Comments on North West Leeds Transport Forum Discussion Document Proposals for Hyde Park Corner

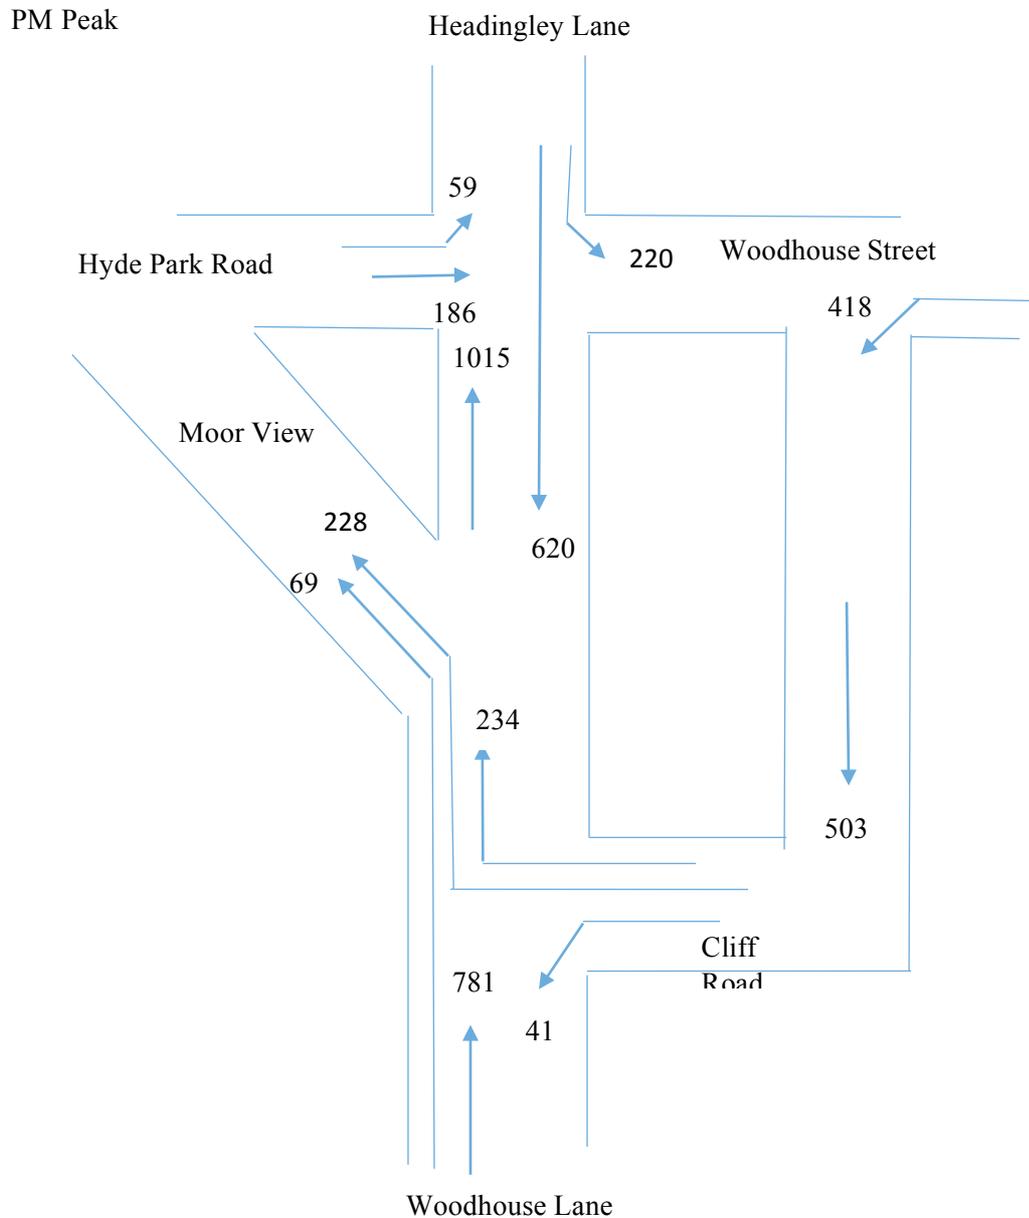
- 3.1 The current vehicle turning counts, taken from NGT planning document APP-6-3-3 (page 22, do nothing case) can be used to demonstrate the effect of the NWLTF's proposal for Hyde Park Corner.
- 3.2 The reassigned turning counts after the implementation of the NWLTF proposal in the AM peak are shown below:

3.3 The reassigned turning counts after the implementation of the NWLTF proposal in the PM peak are shown below:
